SEISMIC MARGINS STUDY  
J. Kovic needs to review the portions of Attachment 2  
relative to UNITED STATES geotechnical engineering

NOTE FOR: George Lear, Chief SGEB  
THRU: P. T. Kuo, Section Leader, Section B, SGEB  
FROM: Frank Rinaldi, Structural Engineer, Section B, SGEB  
SUBJECT: MEETING SUMMARY - TERA's IDCVP

Re: Docket Nos. 50-329 OM, OL and 50-330 OM, OL  
Midland Nuclear Plant - Units 1 and 2  
Independent Design and Construction Verification (IDCV) Program  
Meeting Summary

130.30 With respect to Volume II, Seismic Margin Review: Reactor Containment Building, forwarded by your letter of March 30, 1983, provide the following information:

FIGURE Q&R 130.30.2-5. RVIS Point 120 X-DIR 4% Damping

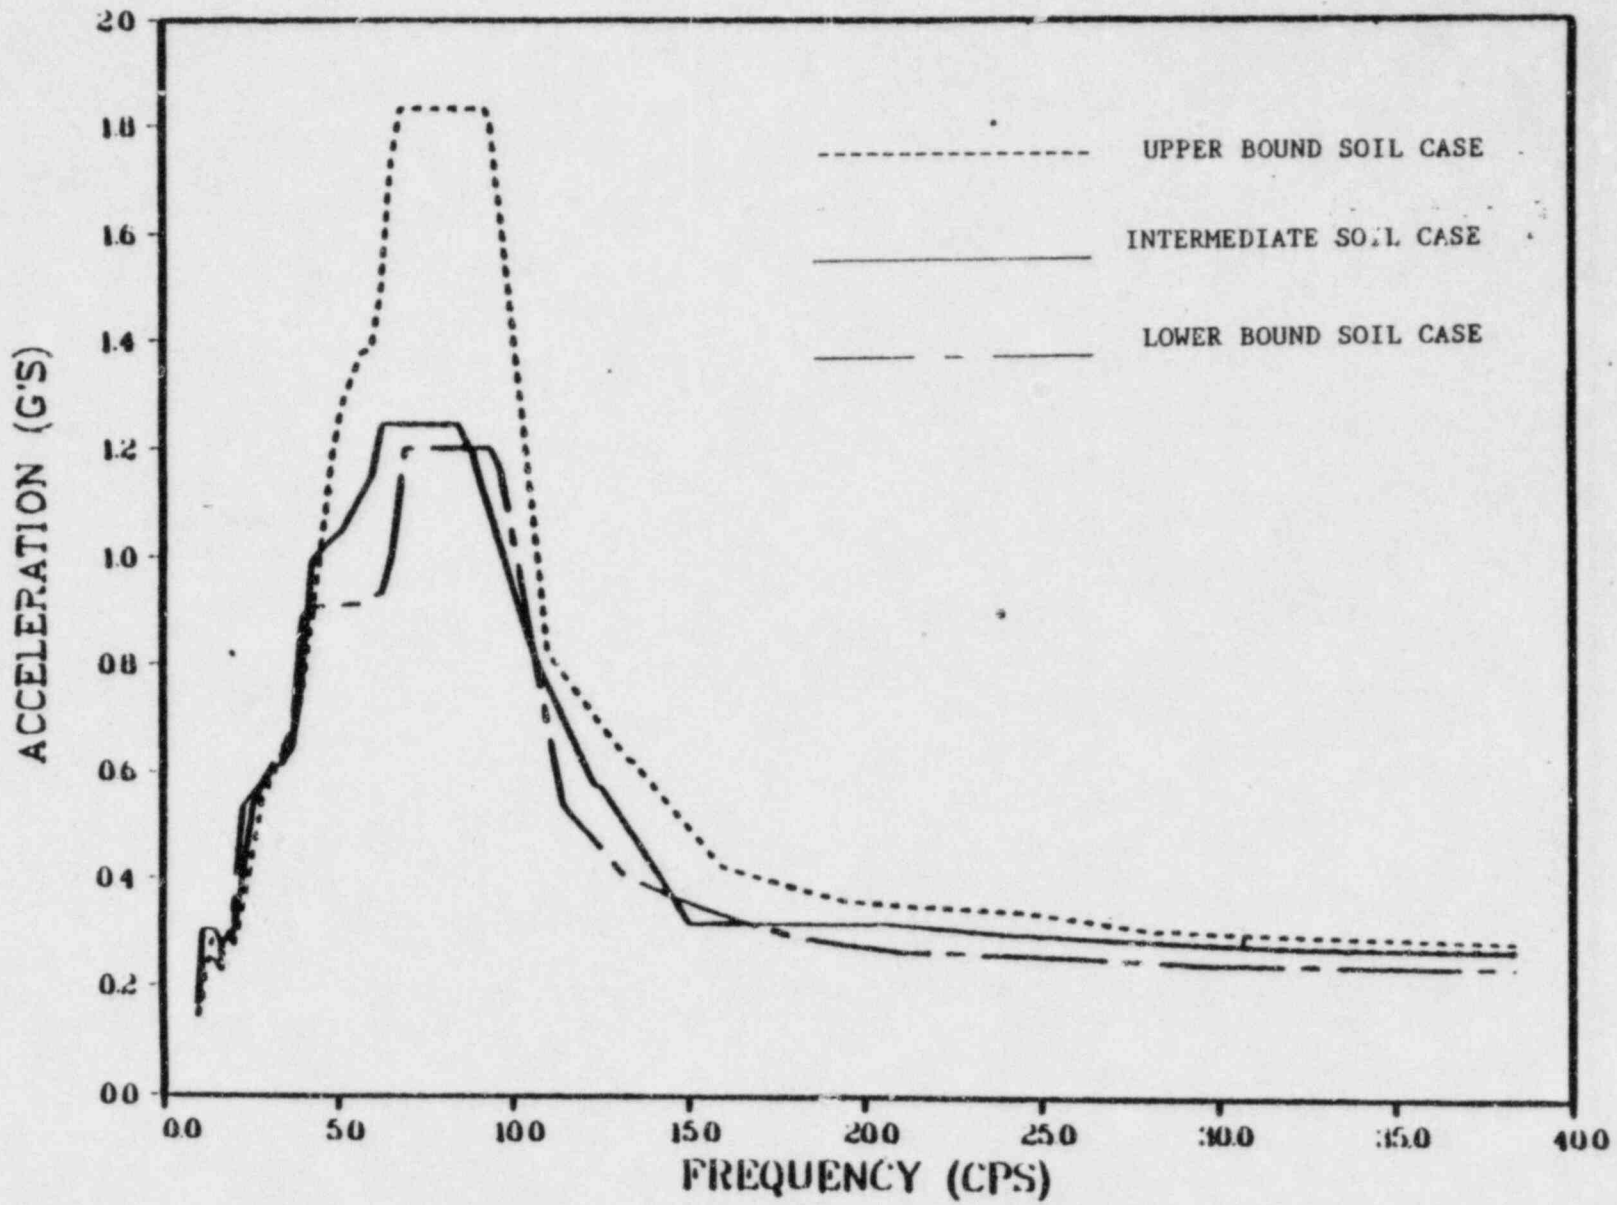
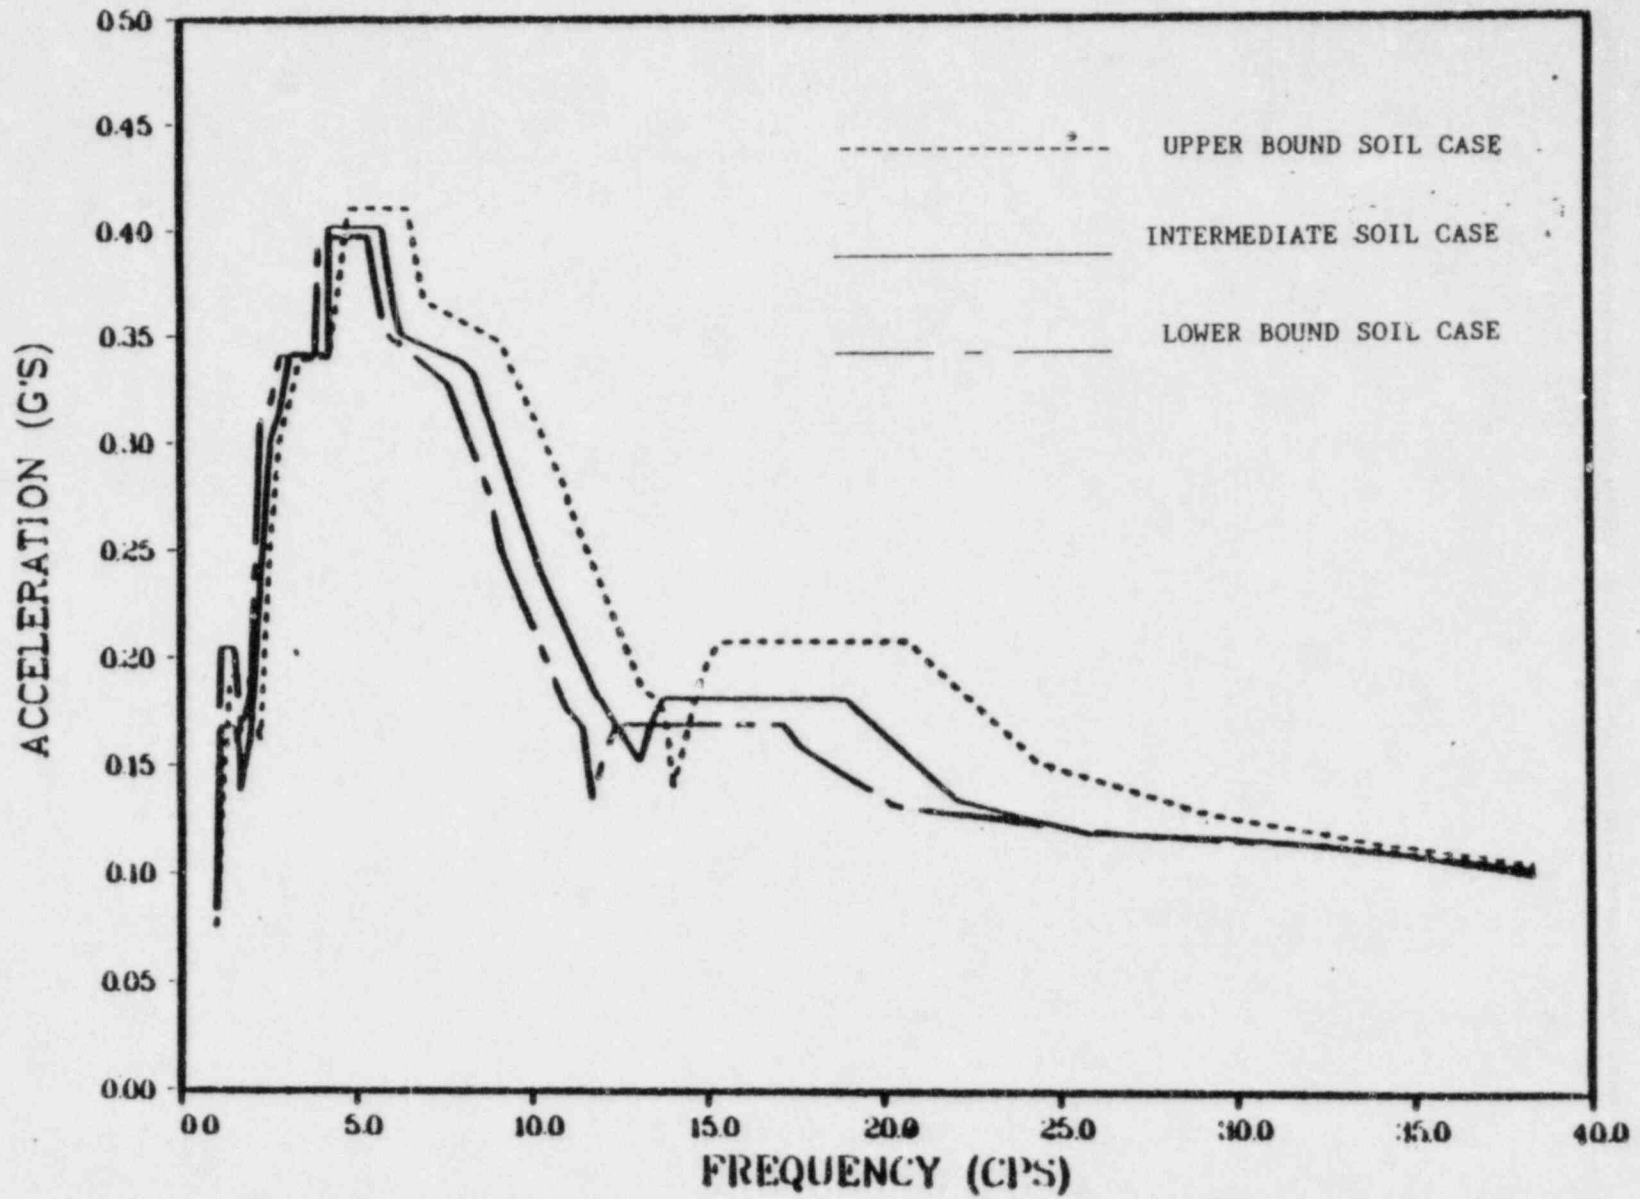
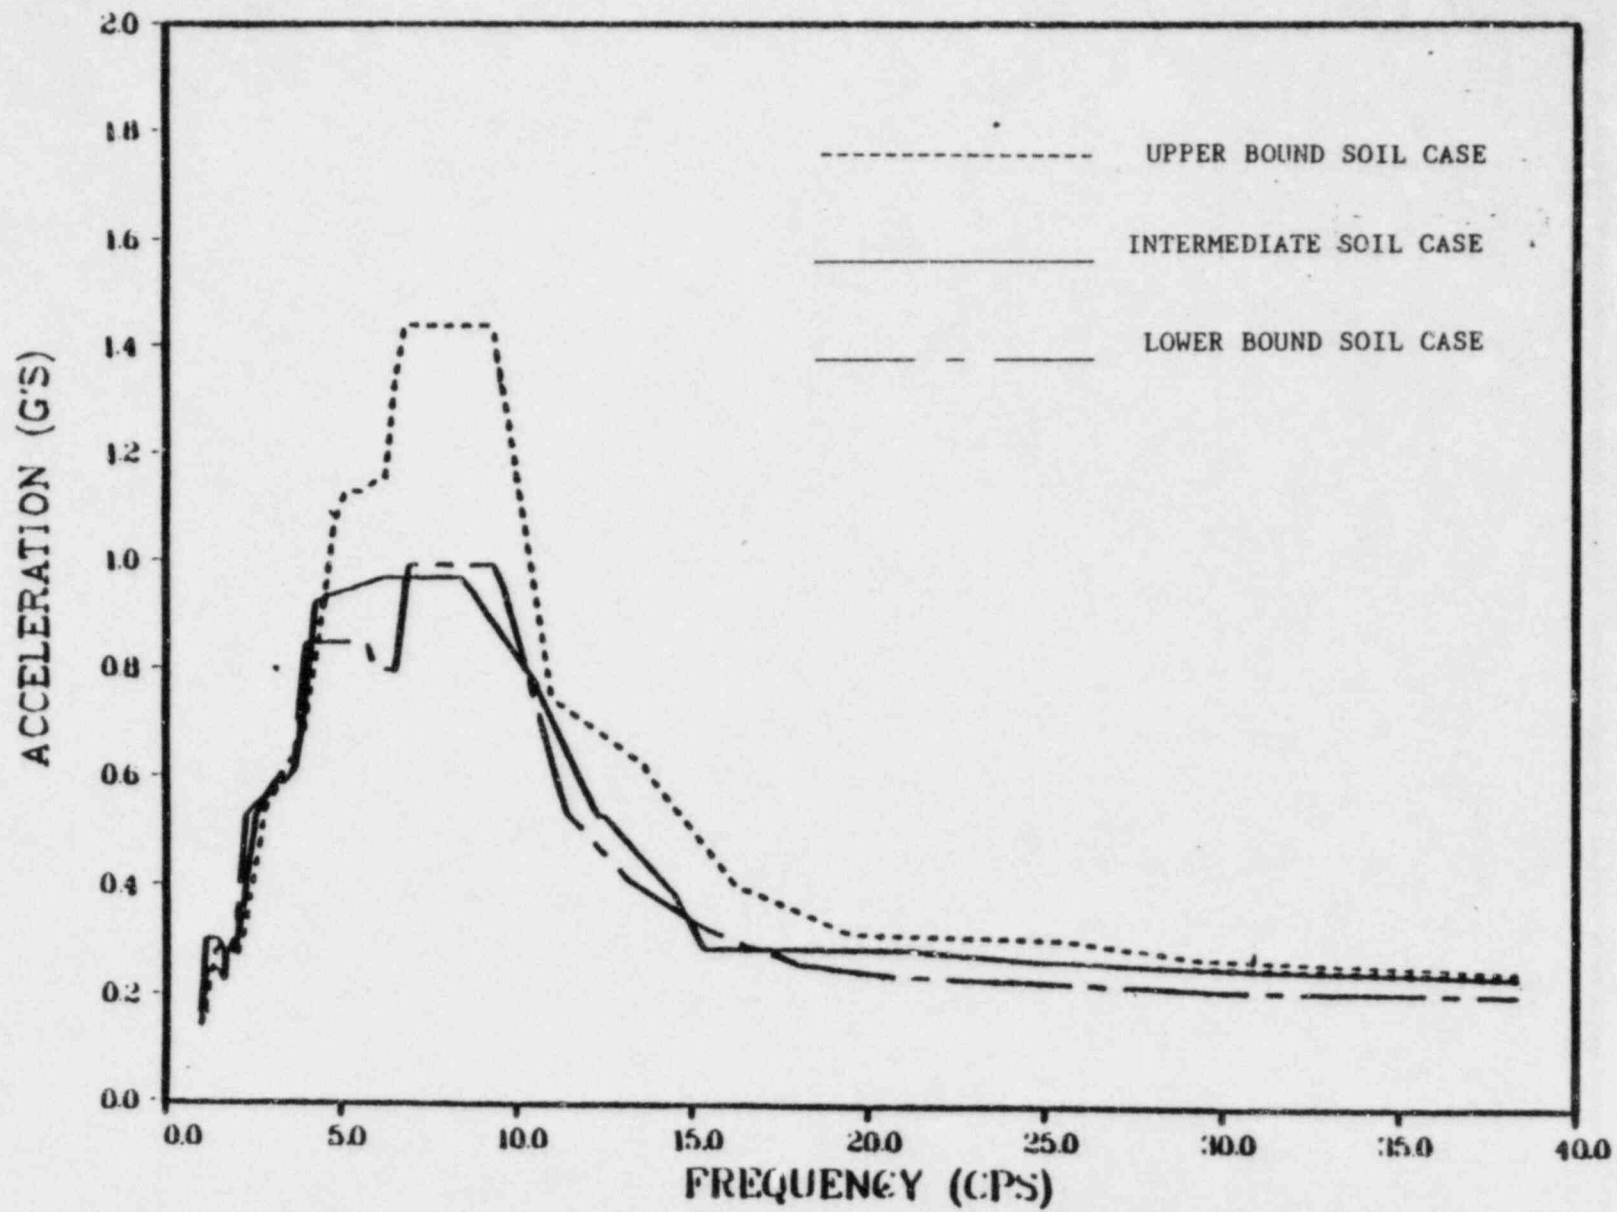
Section 5 of the report presents in-structure response spectra for internal structures. However, none are provided for the steam generators and the reactor vessel. Please provide these missing spectra or justify their omission.

Volume II was written to describe the analysis of the reactor containment buildings and their internal structures. In addition, Volume II presents the in-structure response spectra for use in evaluating equipment attached to the structure. Seismic input at the Nuclear Steam Supply System (NSSS) interfaces in the reactor containment buildings was developed by Structural Mechanics Associates, Inc. (SMA) for the Seismic Margin Earthquake. This input was defined in terms of translational and rotational time histories and response spectra for each of the three soil cases studied. The requested seismic response spectra were generated by Babcock & Wilcox (B&W), the NSSS Vendor. Since the B&W generated seismic response spectra are only an intermediate step in the Balance-of-Plant piping analysis, they were not included in Volume VIII. Figures Q&R 130.30.2-1 through Q&R 130.30.2-7 present the schematic of the reactor vessel model used by B&W and the seismic response spectra for 4 percent of critical damping. Similarly, Figures Q&R 130.30.2-8 through Q&R 130.30.2-17 are presented for the steam generators.
